PRODUCT NEWS BULLETIN

Secondary Foam Filter Now Available For Ford® F-Super Duty (2011-2015 6.7L Turbo Diesel)

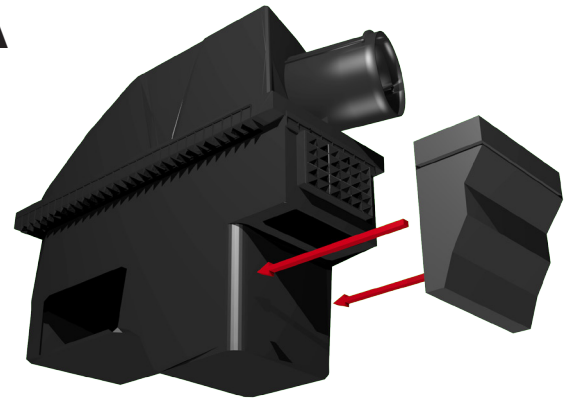
Loss of power due to air flow restriction can occur when snow or ice accumulates inside the air cleaner. The NAPA 500139 low restriction foam filter is recommended to help resolve this issue. This condition is most often encountered on applications that operate in extreme snow conditions such as snow plows. The secondary filter allows the intake of air until the airbox can be cleared of restricting snow and ice.

The use of the 500139 secondary filter is not intended to nor does it replace the use of the primary NAPA 9902 air filter for the 6.7L Turbo Diesel. Service the primary filter based on the vehicle manufacturer's suggested guidelines.
